PEER REVIEW REPORT
OCEAN BOULEVARD EROSION AND ENHANCEMENT
PHASE 2 PROJECT
CITY OF LONG BEACH, CALIFORNIA

CITY OF LONG BEACH
Tidelands Capital Improvement Division

June 23, 2014

Figure 1 - Design Cross-Section of Soil Nailing

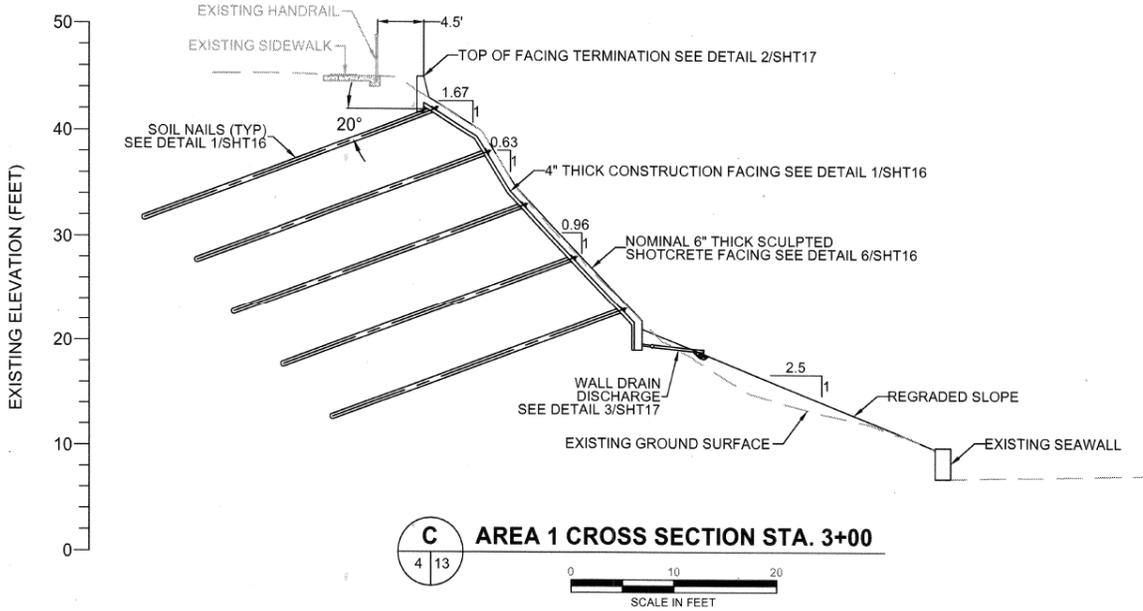
- Soil nails that enhance the deep-seated stability of the bluff under static and dynamic conditions (Figure 1) and locally support portions of the sidewalk; and
- A shotcrete facing (Figure 1) that protects the slope surface from weathering and erosion caused by surface water, and enhances the surficial stability.

Soil nailing with shotcrete facing is commonly used in southern California for bluff stabilization. Examples of successful bluff stabilization projects include the Del Mar Bluffs Stabilization and Pacific Coast Highway Bluff Stabilization in Dana Point and San Clemente.

It is the Committee’s opinion that the recommendations on using soil nailing with shotcrete facing is reasonable considering the project parameters discussed in Section 2.1. An available alternative to shotcrete for slope face protection is using biotechnical techniques as discussed later in Section 3.0.

Figure 2 - Planter Details

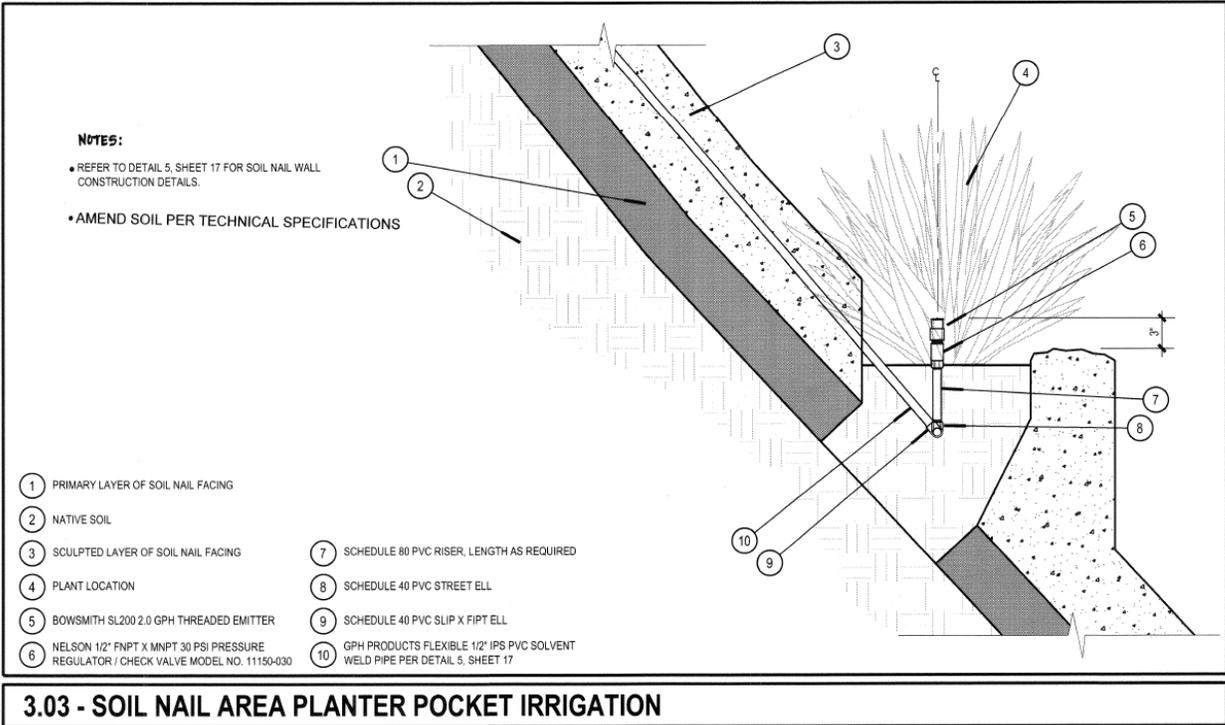
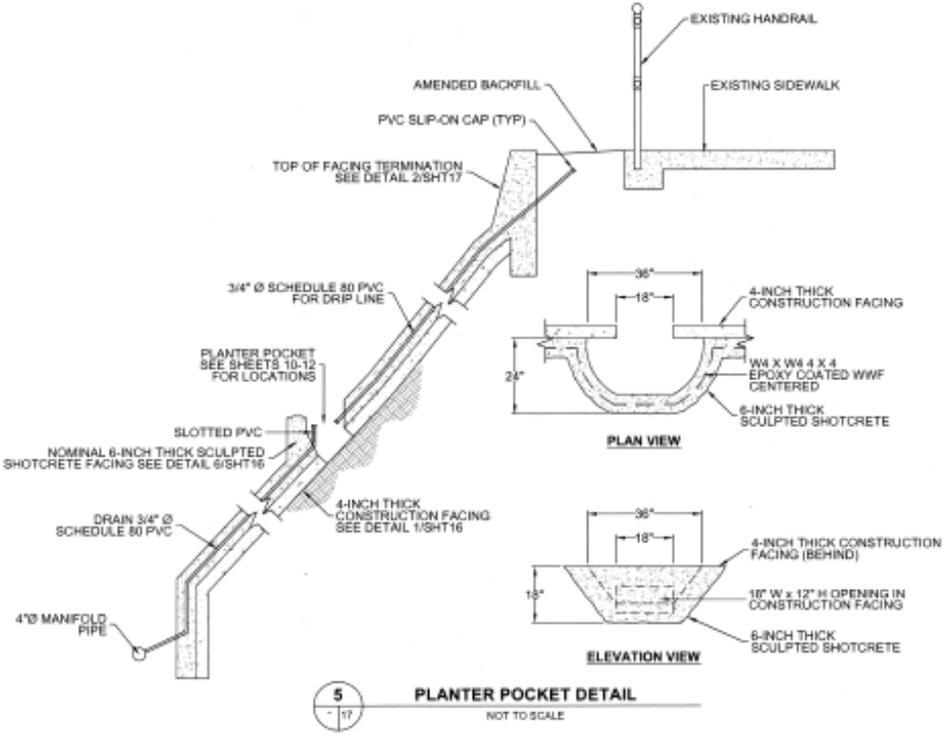
The shotcrete facing will be sculpted to blend in with the surrounding landscape. At specific locations, the shotcrete facing has planter pockets that allow vegetation to grow on the slope and with time will partially cover the shotcrete surface, as exemplified in Figure 2. The design contemplates having open-bottom planters that allow infiltration into the slope. Failure of sprinklers and/or the irrigation pipes may result in a concentrated influx of water directly into the slope which is undesirable. The design includes irrigation PVC pipes embedded into the shotcrete to drain excess irrigation water.

Figure 3 – Example of Deep-Rooted Vegetation

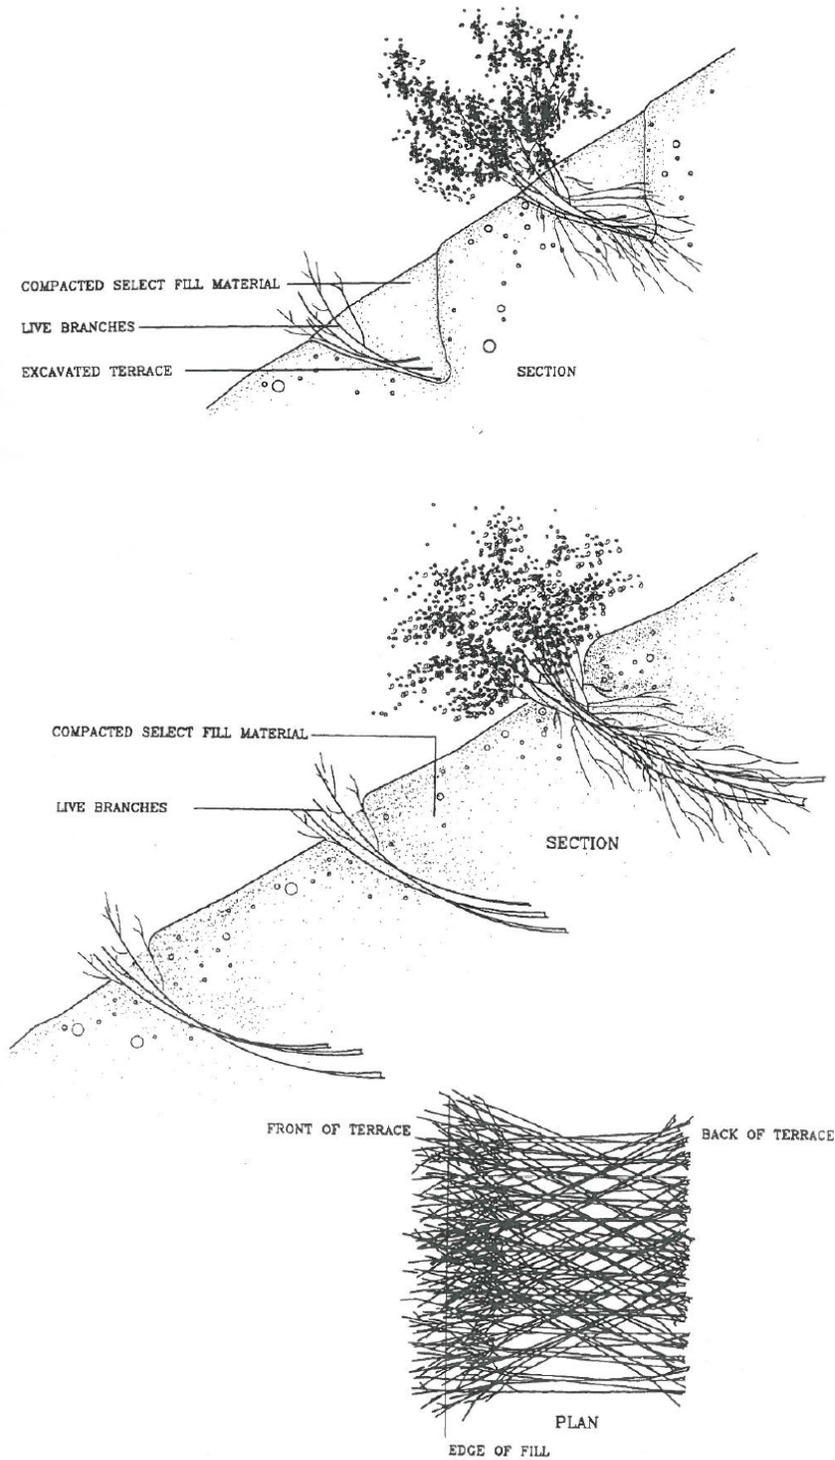
- Deep rooted vegetation as depicted in Figure 3;
- Deep rooted vegetation in combination with geogrid or timber grid used to hold topsoil and slope plantings as shown in Figure 4; and
- Live slope grating where a lattice-like array of vertical and horizontal timbers are fastened or anchored to a steep slope and the openings in the structure are filled with suitable backfill material and layers of live branch cuttings (see Figure 5).

These biotechnical techniques could be considered for the subject slope instead of shotcrete, especially for slope inclinations of 1:1 or flatter. Although biotechnical techniques generally provide excellent erosion protection, the resulting vegetation requires significant maintenance. Biotechnical techniques only improve the stability of the near-surface soils and provide a very limited benefit for deep-seated instabilities; thus, they are not a substitute to soil nails as their depth of influence is limited.

Figure 4 – Example of Deep-Rooted Vegetation with Timber Grid

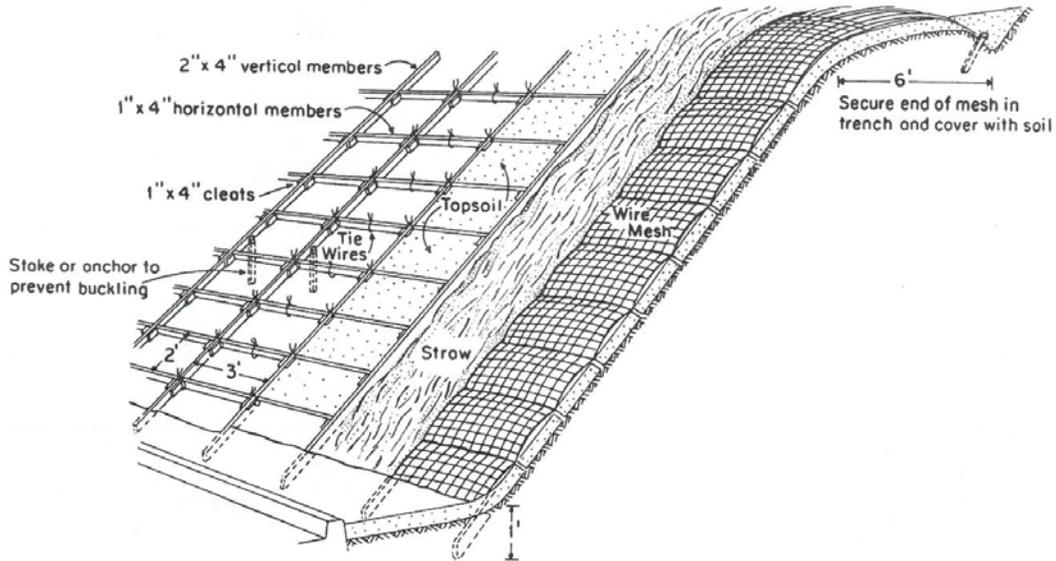
These techniques can be used in the western portion of the project, designated as Area 1 and the western portion of Area 2 on the Construction Plans, where the slope has been stabilized with soil nails but shotcrete has not been installed. Area 1 has slope inclinations varying from 0.63:1 to 1.63:1 (horizontal:vertical) from top to bottom of the slope, which would make the installation of a geogrid or steel mesh facing easier to implement than timber grid or timber grating. Deep-rooted vegetation may be used for the flatter inclination, perhaps in combination with shotcrete or geogrid/steel mesh for the steeper slopes. The western portion of Area 2 has a fairly uniform inclination of 0.85:1 to 1:1 (horizontal:vertical) that can facilitate the biotechnical options mentioned above. Minor grading may be required to create a bench to support the timber grids or grating. Due to steepness and variety of inclinations of the slope, biotechnical
